TELEVISION TECHNICAL BULLETIN

<u>MODELS</u>	51CS03H	59CS03H	66CS03H
	66CS05H	51CS05H	59CS05H

Location of wire link on the component side of the PWB

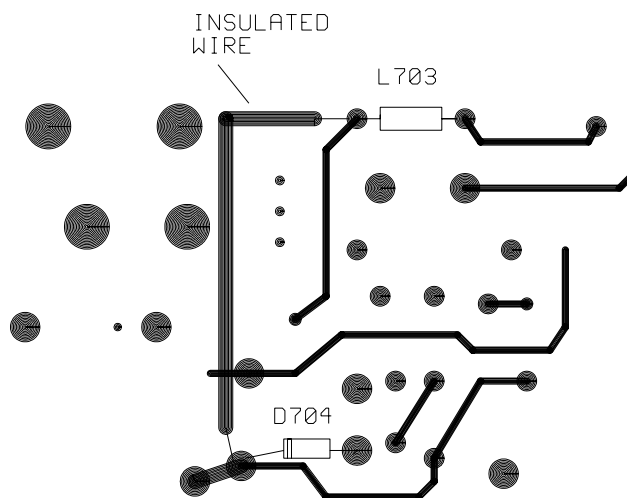
SYMPTOM The set remains in the standby mode.

CAUSE Crack on the PWB due to transport damage.

ACTION If there is no 300VDC across C708, then check the continuity between L703 and the cathode of D704. If this is open circuit, fit a wire link between the two points as indicated in the diagram below.
